Model: K-C4L/C4a	Date: 28-Dec-12	No.: RD160001g
------------------	-----------------	----------------

Subject: Firmware Release Note: BICU_IC		Prepared by: Y.Suzuki	
From: 2nd Tech Service Sect., MFP/Printer Tech Service Dept.			
Classification:	<input type="checkbox"/> Troubleshooting <input type="checkbox"/> Mechanical <input type="checkbox"/> Paper path <input type="checkbox"/> Product Safety	<input type="checkbox"/> Part information <input type="checkbox"/> Electrical <input type="checkbox"/> Transmit/receive <input checked="" type="checkbox"/> Other (Firmware)	<input type="checkbox"/> Action required <input type="checkbox"/> Service manual revision <input type="checkbox"/> Retrofit information <input checked="" type="checkbox"/> Tier 2

Model: K-C4L		Date: 1-Sep-14	No.: RD160007
Subject: How to adjust the LE registration		Prepared by: Y.Saitoh	
From: 2nd Tech Service Sect., MFP/P Tech Service Dept.			
Classification:	<input checked="" type="checkbox"/> Troubleshooting <input type="checkbox"/> Mechanical <input type="checkbox"/> Paper path <input type="checkbox"/> Product Safety	<input type="checkbox"/> Part information <input type="checkbox"/> Electrical <input type="checkbox

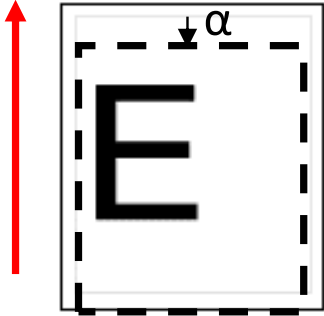
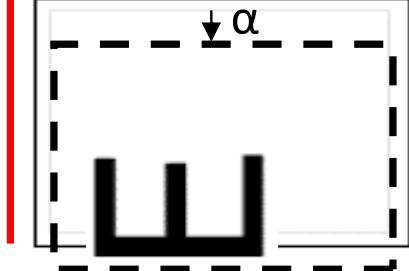
The leading edge registration settings are not applied in the vertical direction of the image with copy or print jobs, if the paper is loaded in the tray **at 90 degrees to (i.e. in the opposite orientation of) the original.**

The image must be rotated 90 degrees if the paper is loaded perpendicular to the direction of the image on the original (see “2. Rotate 90” below). As a result, the leading edge registration settings (See “ $\alpha$ ” below) are not applied in the direction of the image, as the user would expect.

1. Load the paper in the tray in the **same direction** as the image on the original, and then adjust the leading edge registration, and:
2. Do the registration adjustment with the following SP modes:  
 Simplex: **SP1-001-002**  
 Duplex: **SP1-001-002 and SP1-001-013**

Original Document	①The setting up $\alpha$	②The setting down $\alpha$

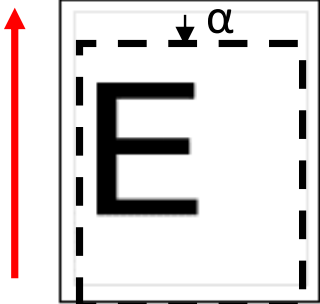
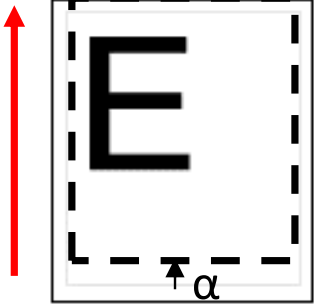
- 1) For duplex, the value of **SP1-001-002** is applied to **page 2** (the rear side). This is because in duplex mode, the second image is printed first. The value of **SP1-001-013** is then applied to **page 1** (the front side).
- 2) **Higher** values shift the image toward the **trailing** edge, and **lower** values toward the **leading** edge (See "The setting up  $\alpha$ " and "The setting down  $\alpha$ " below, respectively).

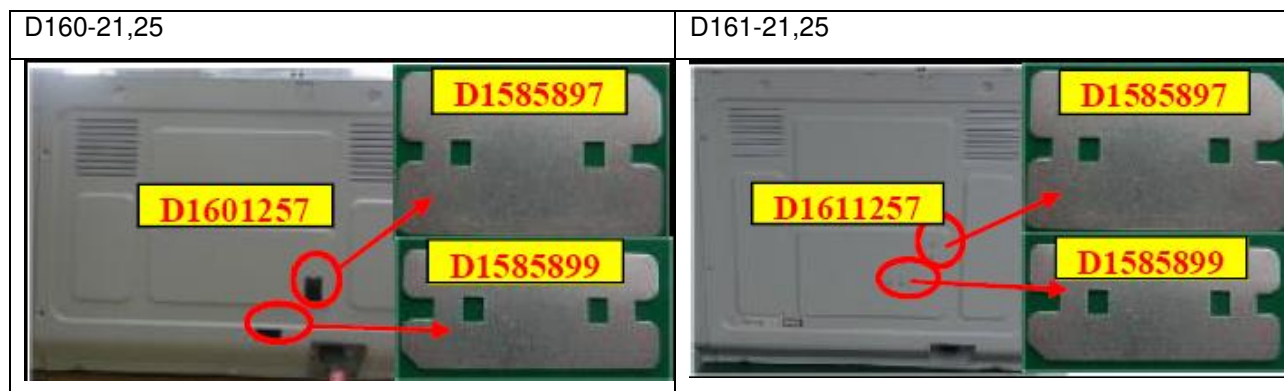
**Change:** The color of rear cover was changed (for China model only)

**Reason:** The material was changed.

**Note:** There is no difference in function between the old and new rear covers. The part number was changed for control purposes. Therefore, these parts do not have to be replaced as a set if the color difference is acceptable to the customer.

## ⚠ CAUTION:

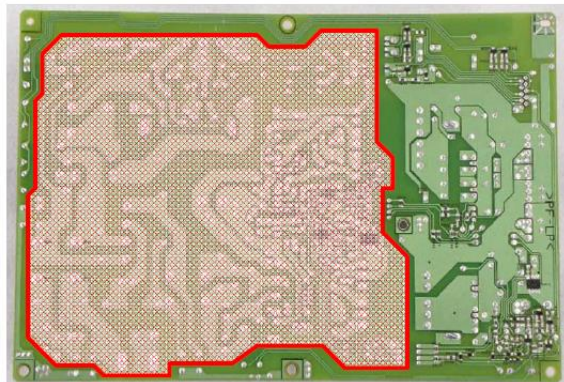
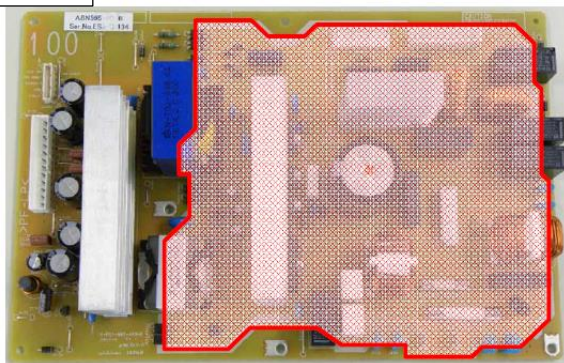
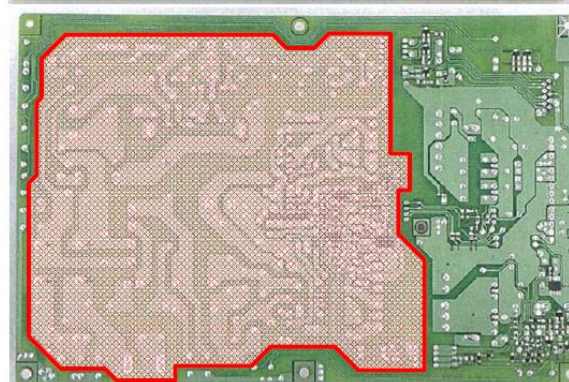
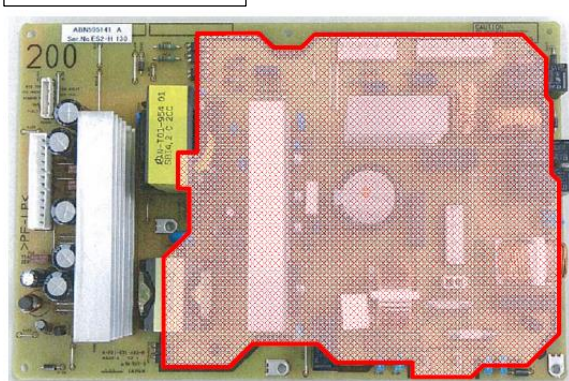
**NEVER touch** the areas outlined in red in the photos below, to prevent electric shock caused by residual charge.

Residual charge of about 100V-400V remains on the PSU board for several months even when the board has been removed from the machine after turning off the machine power and unplugging the power cord.
